# Service Bulletin

Bulletin No.: 20-NA-017

**Subject: Outward Bump on Surface of Front Fascia (ZL1 or ZL1 1LE for U.S. and Canada Dealers Only)**

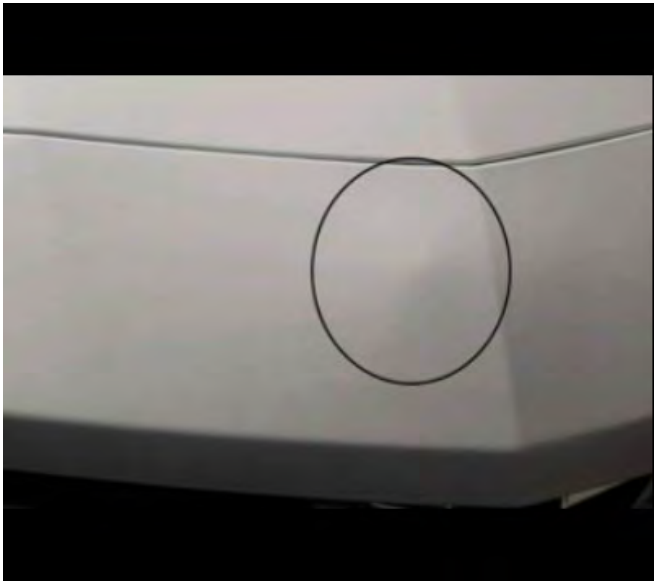
<b>Involved Region or Country</b>	United States, Canada
<b>Condition</b>	 <p style="text-align: right; font-size: small;">5484962</p> <p>Some customers may comment on an outward bump appearance in the front fascia. This condition only occurs approximately 76 mm (3 in) on either side of the centerline of the fascia.</p>
<b>Cause</b>	This condition is caused by the corners of the grille support bracket creating an outward ding due to excessive downward force on the front fascia area.
<b>Correction</b>	<p><b>Important:</b> Before you repair a vehicle with this condition, please submit a Field Product Report along with pictures of the issue. In Canada, please submit a Product Information Report.</p> <p>Rework the fascia to remove the bump following the steps in the Service Procedure below.</p>
